IEE802.3 4P Task Force

Updating E2EP2P_Iunb numbers per latest changes in Draft D1.2
and September discussions

October 2015

Yair Darshan/Microsemi

~~Figure 33–18a—PD PI Icon-2P_unb test~~**fault tolerance test circuit**

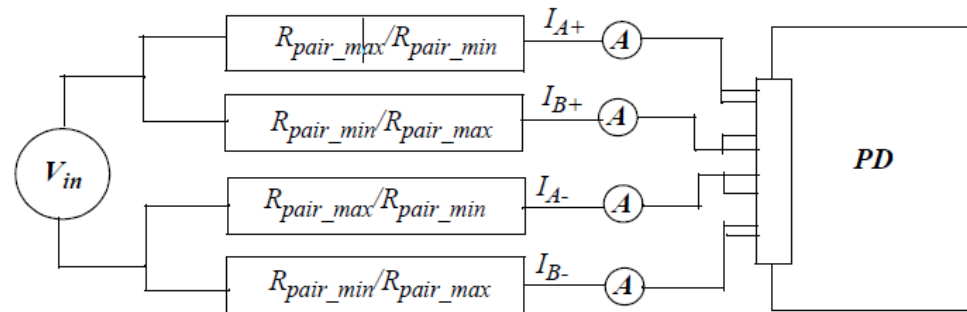
All Class 5 and higher PDs shall not exceed Icon-2P-unb (Table 33–11, item 4a) on ~~any pair.either pairset~~ PDs shall meet this requirement when connected to a common source voltage through a resistance of $R_{source_min}=0.16\Omega\pm 1\%$ and $R_{source_max}=0.19\Omega\pm 1\%$ (Editor Note: add longer channel resistance) to PD PI pairs of the same polarity (See Figure 33-18a), for all PD operating conditions.~~tested according to section 33.3.7.10.1.~~

R_{source_max} and R_{source_min} ~~R_{pair_min} represents~~represent the V_{in} source impedance that is consist of PSE PI components (R_{pair_max} and R_{pair_min} as specified in 33.2.7.4.1) and channel resistance.~~effective source impedance that includes the effect of $V_{Port_PSE_diff}$ as specified by Table 33–11 item 1a.~~ I_A and I_B are the pair current of pairs with the same polarity.

See Annex 33A.5 for design guide lines for meeting the above requirements.
